OVERALL CIRCUIT DIAGRAM
JC-120 serial No. 512500 and higher
JC-160 serial No. 510850 and higher

CORRECTION SHEET

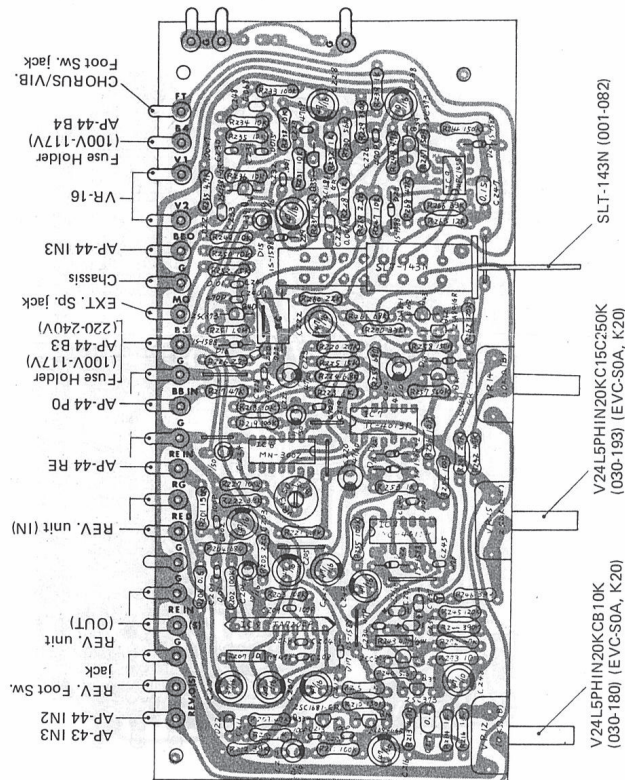
The patterns of PS-19 on page 4 and PS-18 on page 8 are printed upside down. Please attach the followings to corresponding parts.

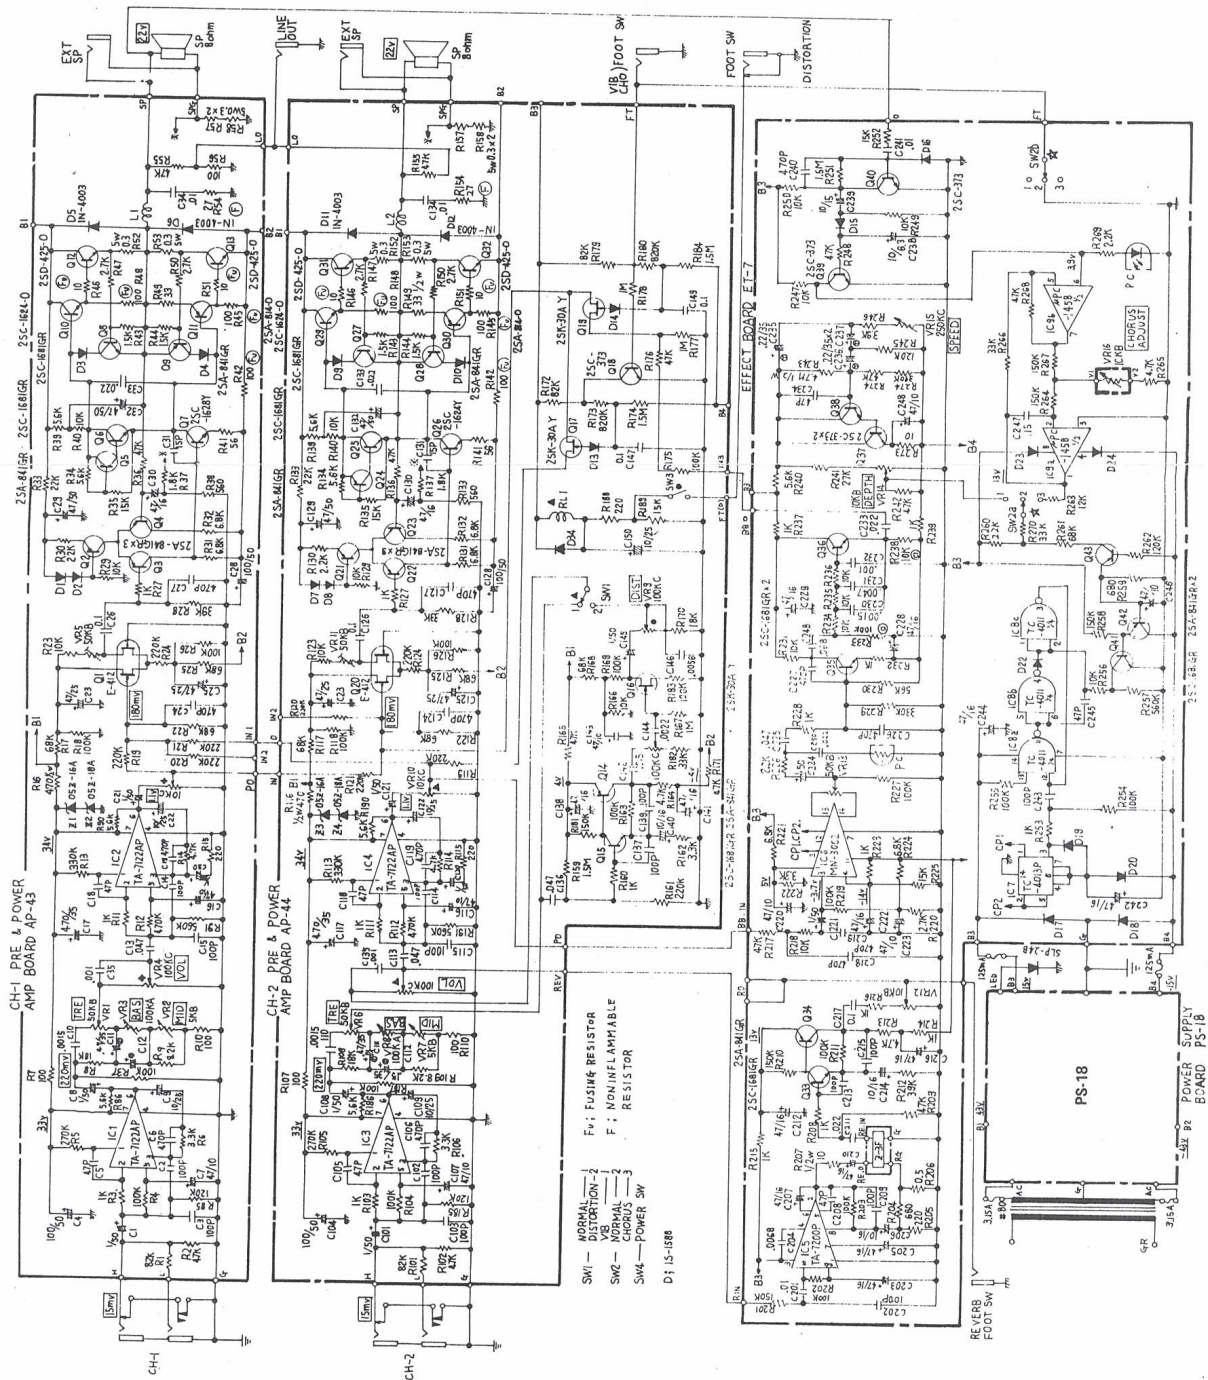
AP-44 parts modification					
JC-120 522850 JC-160 520950	Q16, Q17, Q19 25K30A(GR) → 25K30A(Y)	R101 47K → 82K	R134 4.7K → 5.6K	R108 3.3K → 8.2K	C135 0.0047μf → 0.001μf
JC-120 543650 JC-160 541050	C117 100μf 50V → 470μf 35V				
JC-120 564200 JC-160 561100	R142, R145, R146, R148, R151 1/4R → fusing resistor	R116, R149 1/4W → 1/2W			
ET-7 parts modification					
JC-120 522850 JC-160 520950	R266 39K → 33K				
JC-120 543650 JC-160 541050	pc board 052-190A → 052-199	C240 0.0022μf → 470pf			
JC-120 574500 JC-160 571250	D21 1S1588 → omitted	C250 0 → 0.022μf	C238 100μf 6.3V → 10μf 16V
